Planning Statement

1 Fitzroy Road, Camden, London, NW1
8TU

June 2016

PHCAAC Rebuttal

2.0 Respecting the Existing House

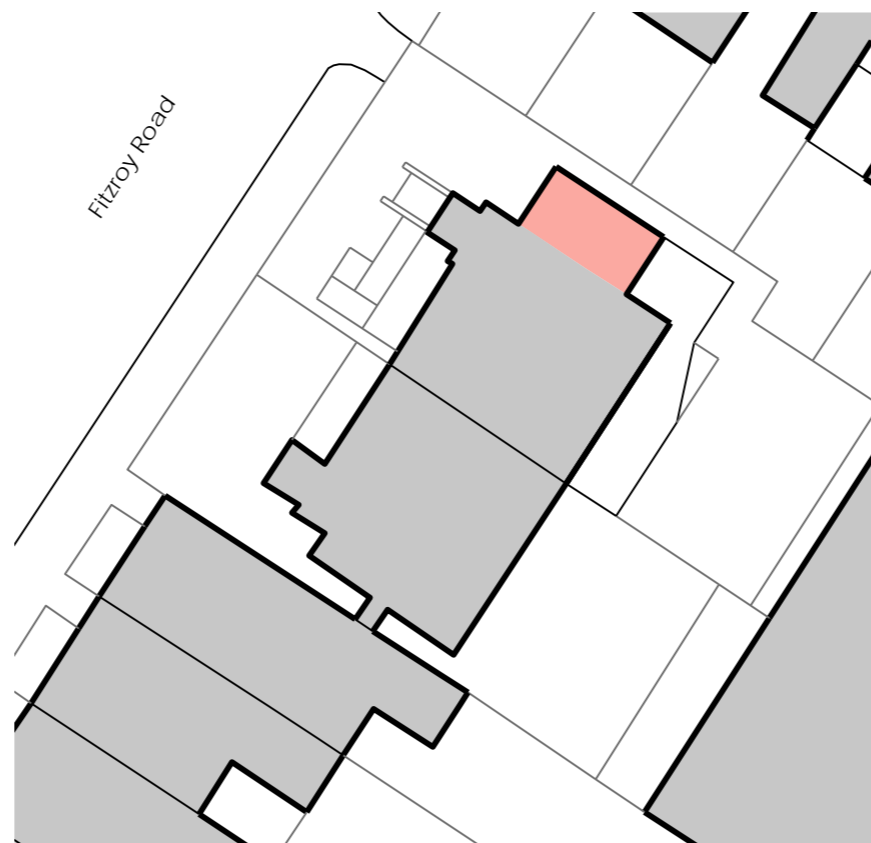
Comment: Opposed to the degree of wrapping of the existing house.

The existing house has been subject to a variety of built additions over the years, the garage currently encloses the corner of the existing house up to raised ground floor level. This is accessed via a concrete hardstanding ramp, a feature uncharacteristic of the Conservation Area. Our proposed extension respects the existing building line established by the current side addition, furthermore the massing steps down to the rear of the site carefully following the topography and maintaining the existing relationship. The resulting refurbishment and design are unquestionably modern, rather than mimicking Neo-Georgian architecture or resorting to pastiche. The extension is recognizable as a reinterpretation of the current house, both restrained in its architectural treatment, and subtle as a contemporary addition.

Existing: The existing house has suffered various alterations over the years with side extensions enhancing the asymmetric composition of the pair. Critically, the current garage extension extends to the corner of the existing house.

Proposed: The extension to the north of the house follows the building line and holds the proposed stair. This element steps back from the corner of the rear of the house at raised ground floor level, freeing up the original volume.

3.0 Proposed Massing

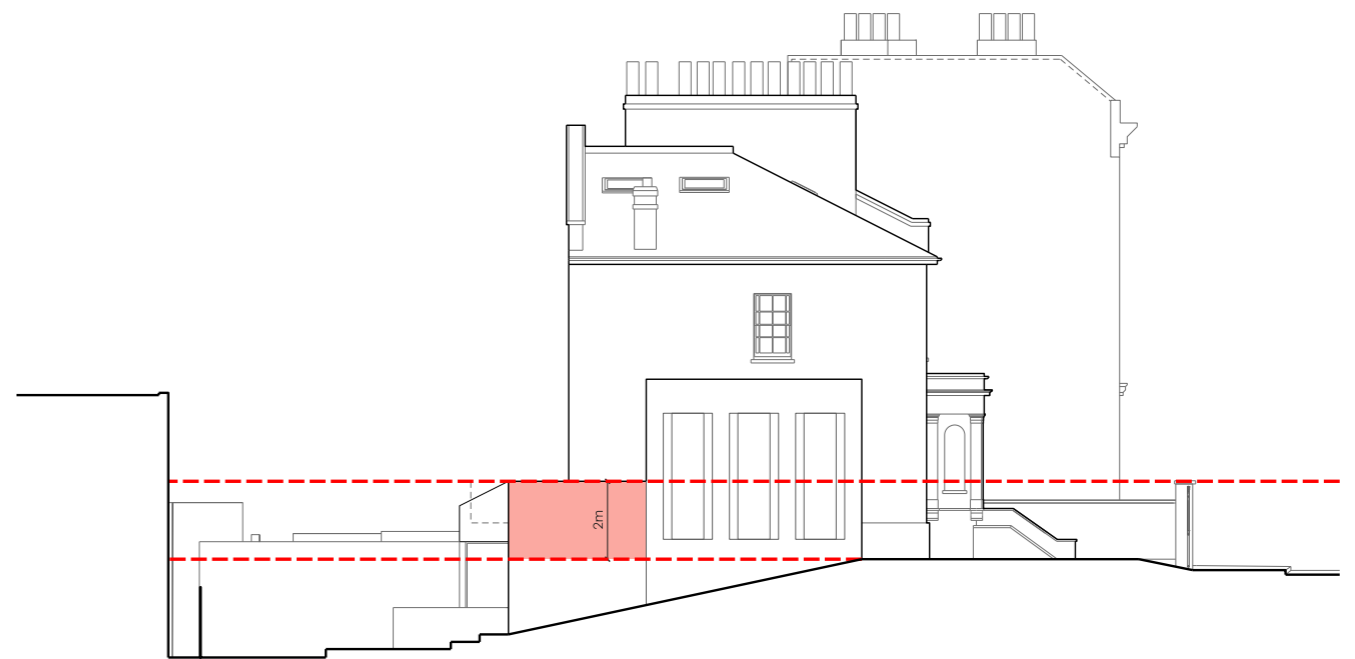
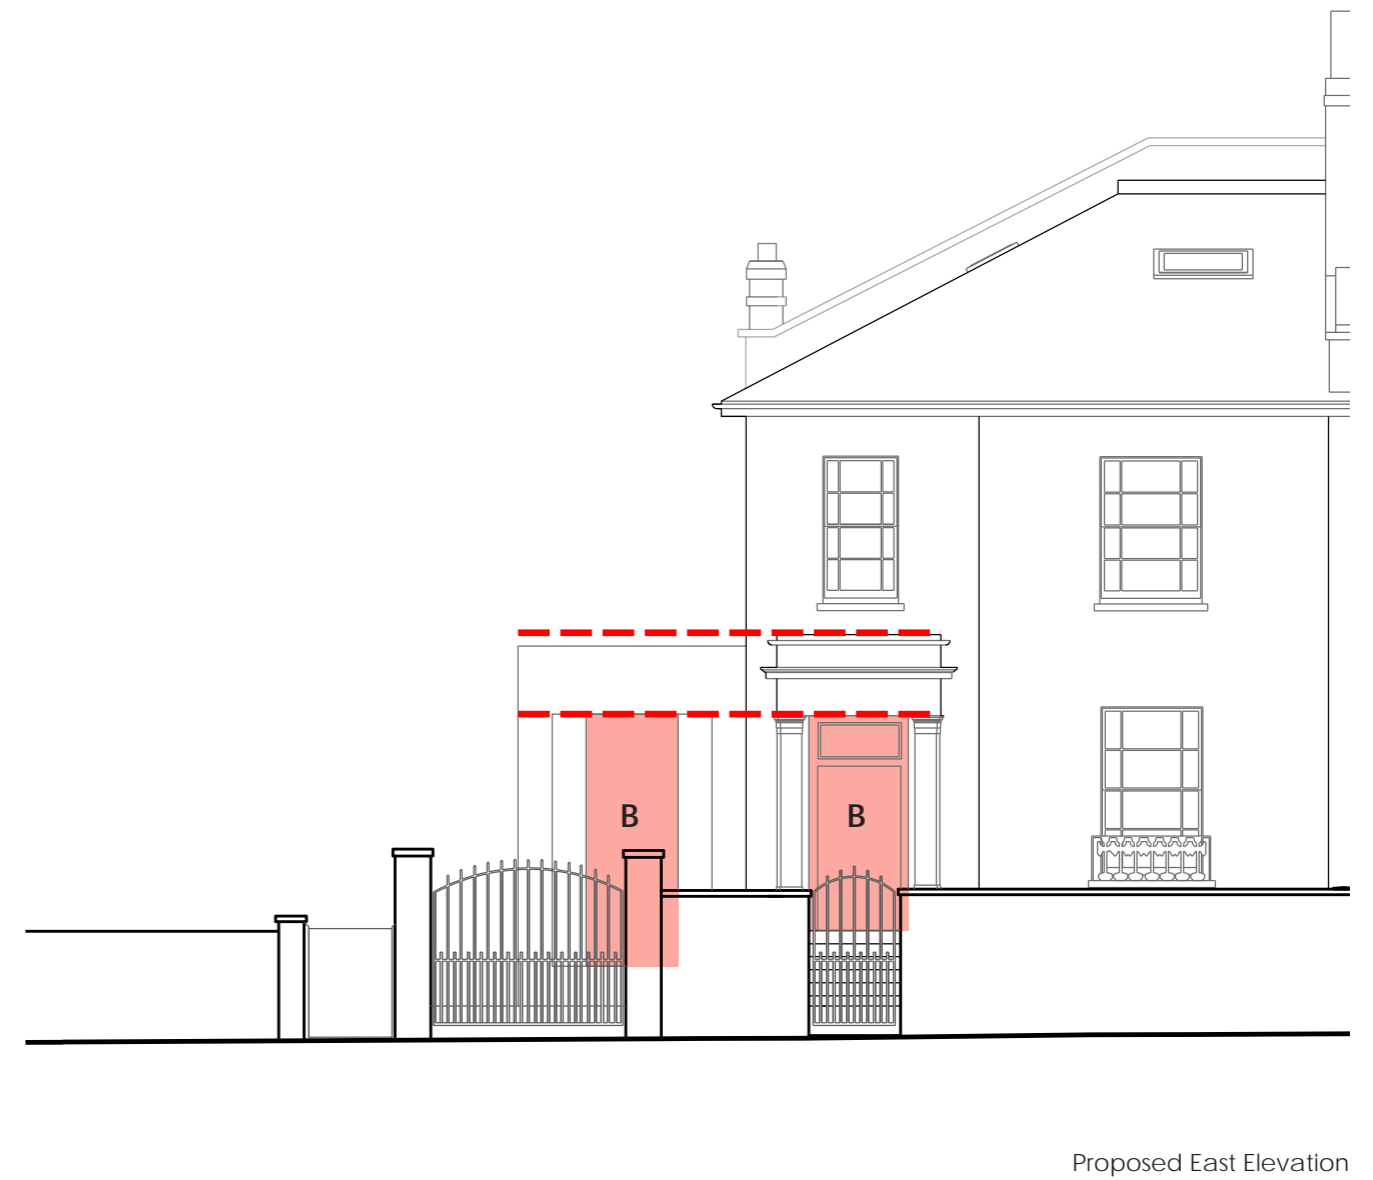
Comment: Excessive in scale and bulk compared to the original house

Response: The side extension is one and a half storeys high and clearly ancillary to the main two storey house. We have reduced the height of the side extension, dropping it below that of the porch and emphasising its subservient relationship to the existing house. The rear extension respects existing site levels and steps down to become a single storey element at the back of the house. When considered within the context of haphazard development to the rear gardens of neighbouring dwellings (Refer to West Elevation overleaf), the proposal appears calm and restrained. The stepped nature of the massing provides visual interest within the context of the Conservation Area, reducing the bulk of the proposal and allowing glimpses of planted landscaping to be viewed from the street.

4.0 Materials and Detailing: Rhythm

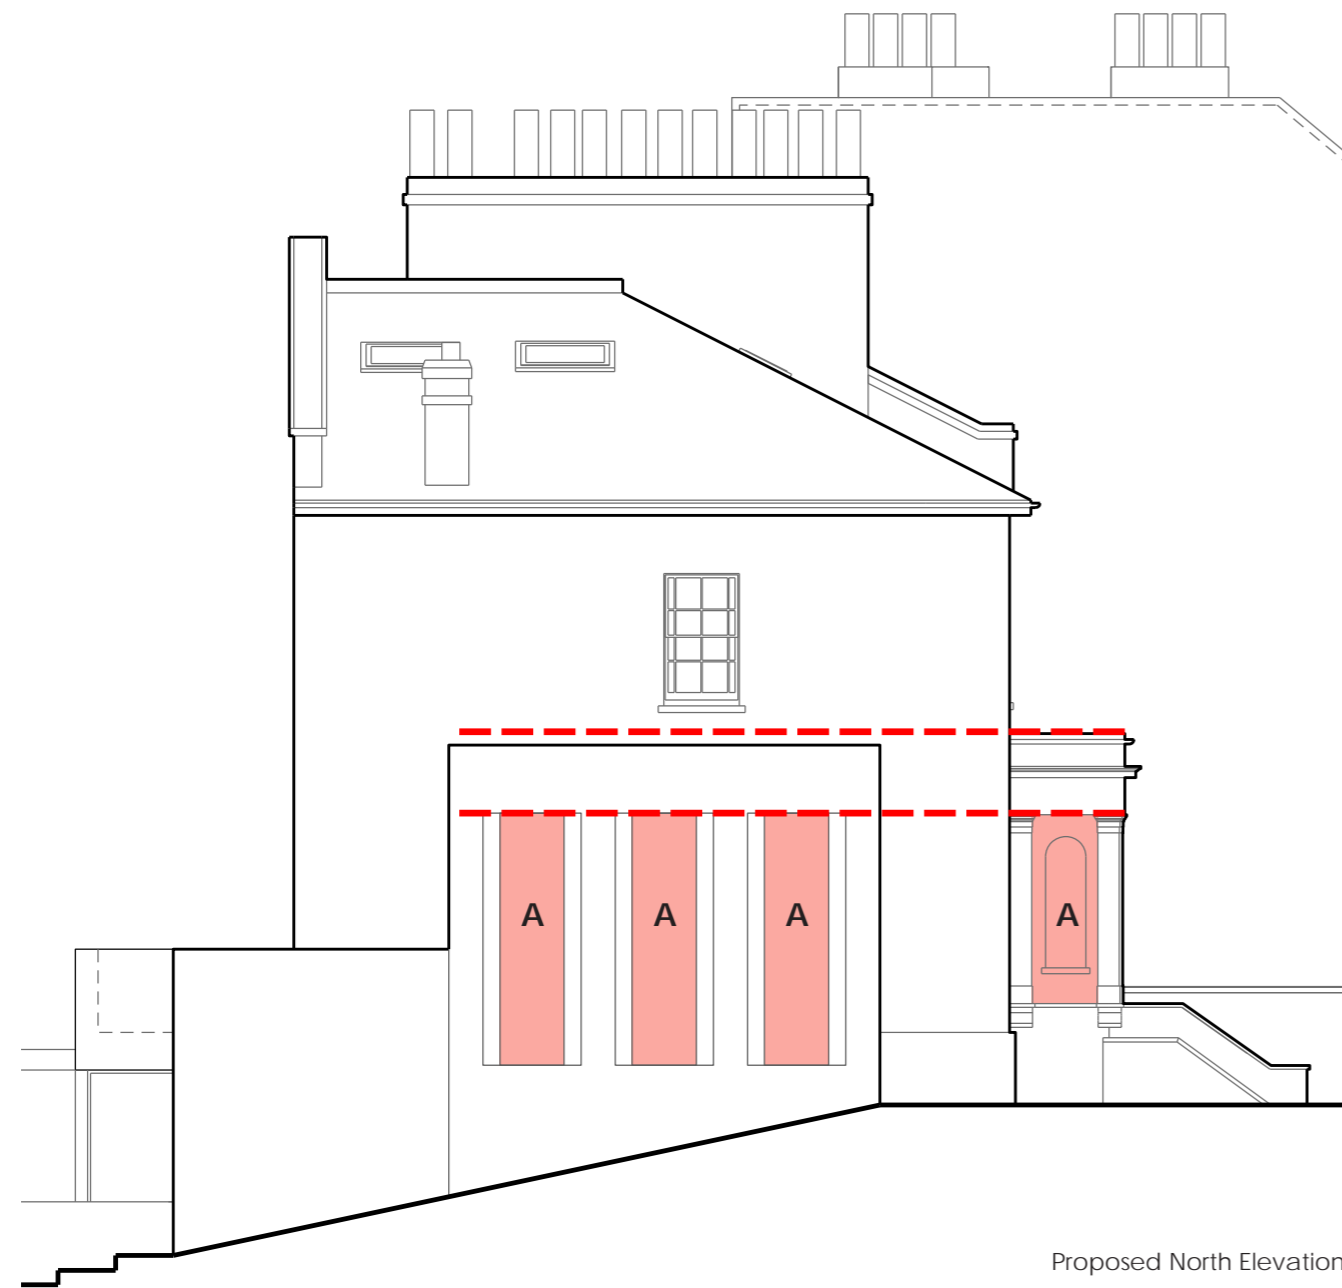
Comment: Reduction in height and width could better respect proportions of original house.

Response: The form and composition of the recessed panels is carefully derived from the existing house, respecting both the proportion and scale of the pilastered porch. Furthermore, the proposed side extension is set back from the main house, following the existing building line and ensuring the proposal remains subsidiary to the main body of the house. The proposed side extension holds a stair that connects lower and raised ground floor levels, it's height and width are therefore dictated by the provision of a generous staircase and crucially by the existing building floor to ceiling dimensions.

5.0 Building Footprint

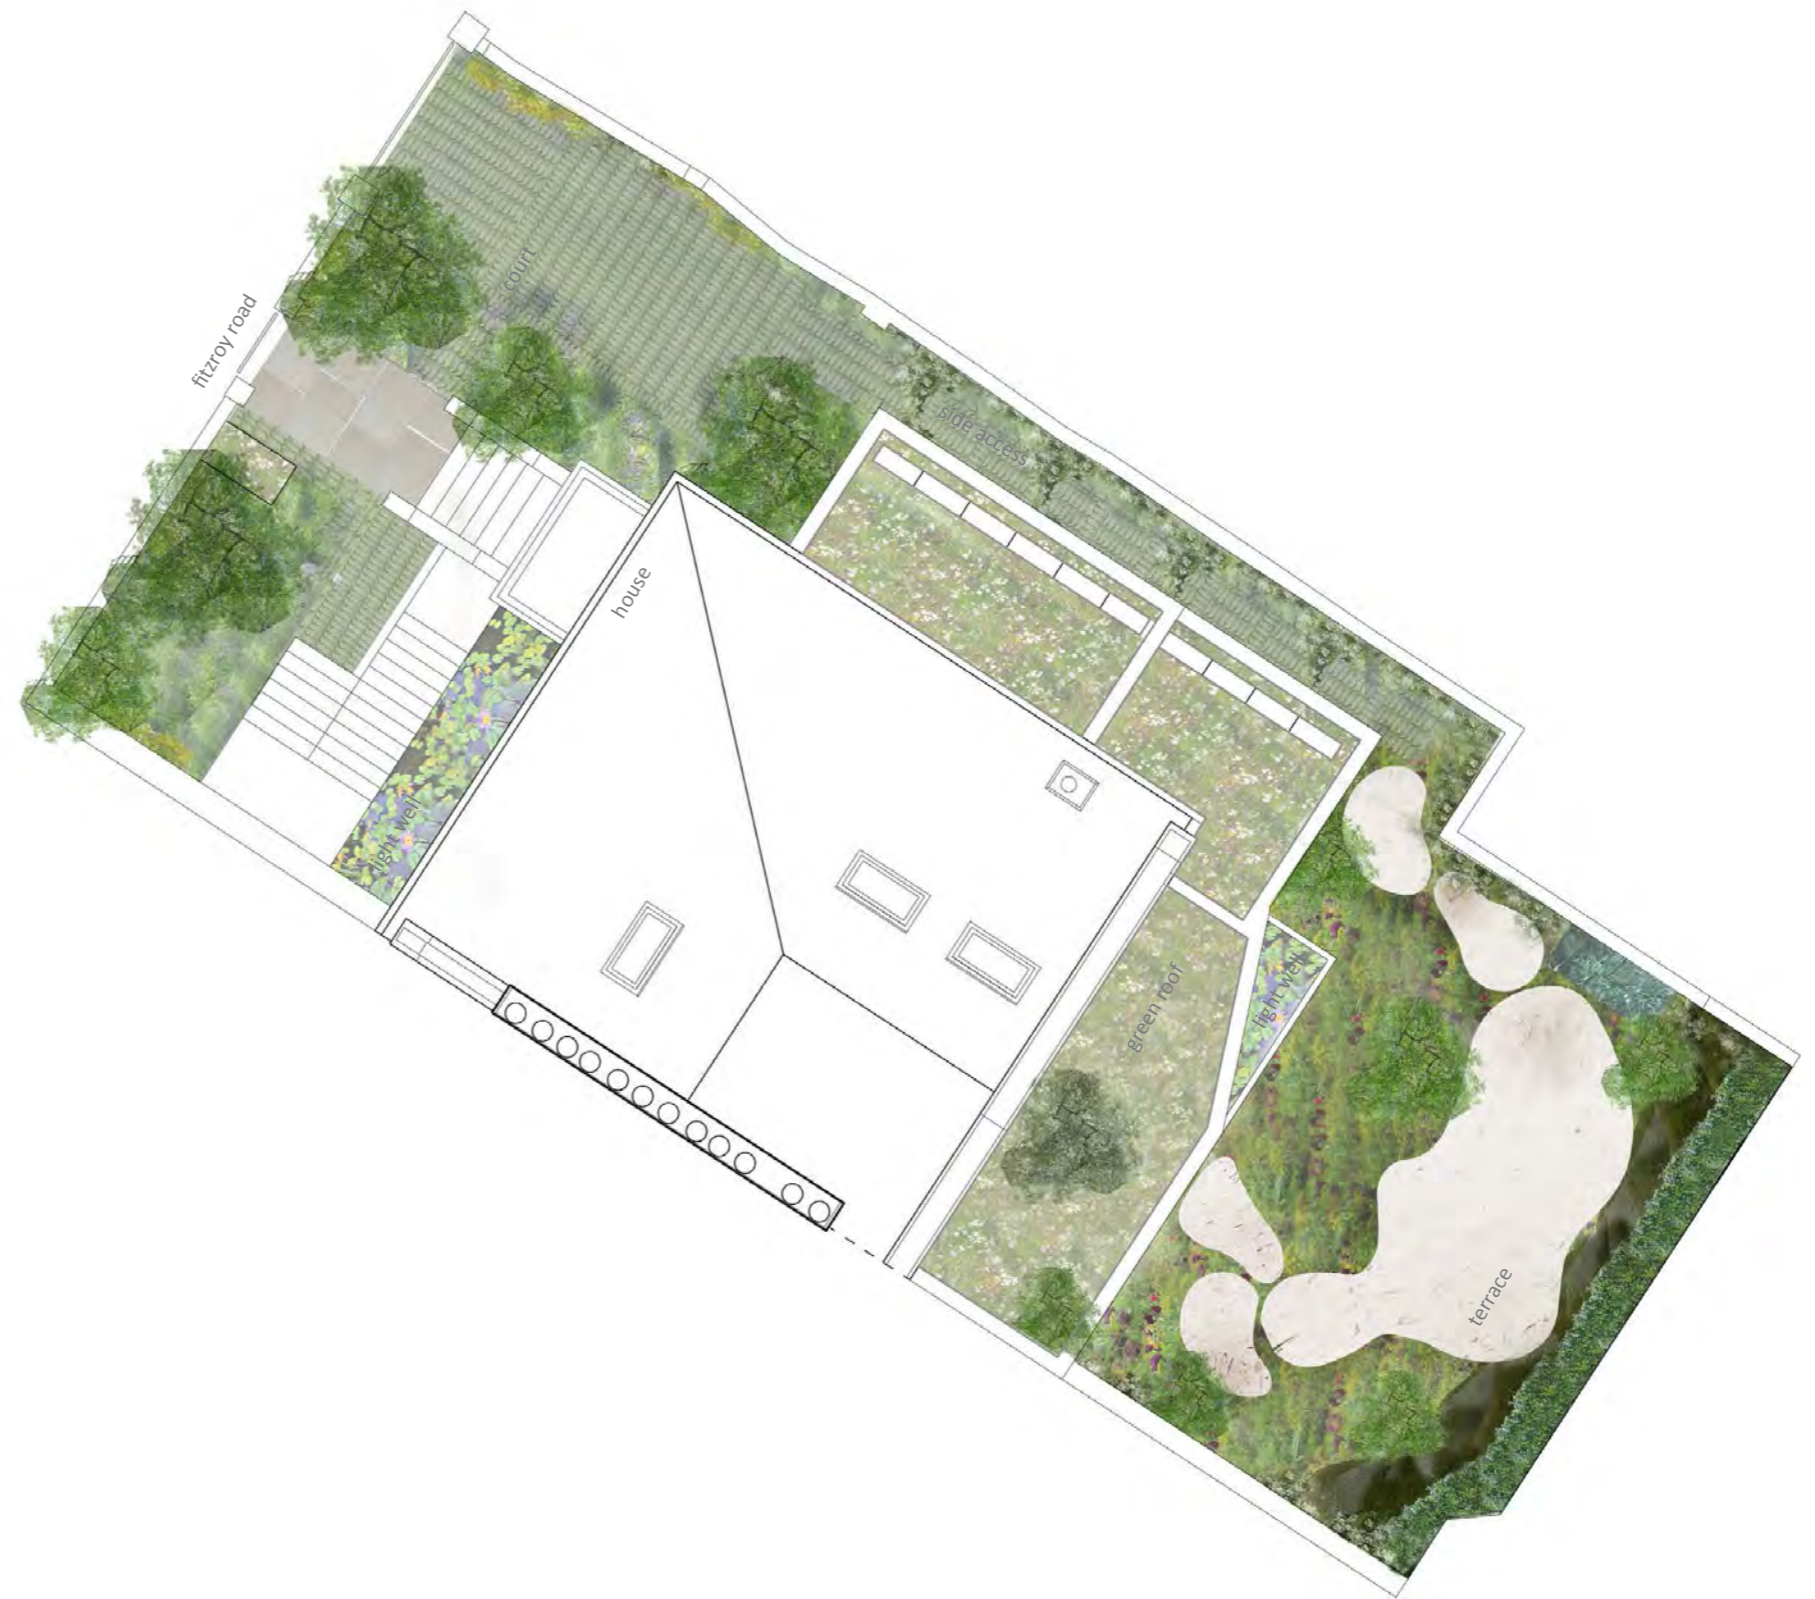
Comment: Extent of existing footprint to the rear of the house.

Response: The proposed refurbishment of the existing dwelling has sought to both minimise any increases in footprint while also maximising the amount of amenity space and engagement with the garden. The rear extension remains entirely set back from the boundary and is also stepped in plan to the rear, an aspect of the design which softens the impact of the proposal at the corner of the house where the extension is only 1.5m deep.
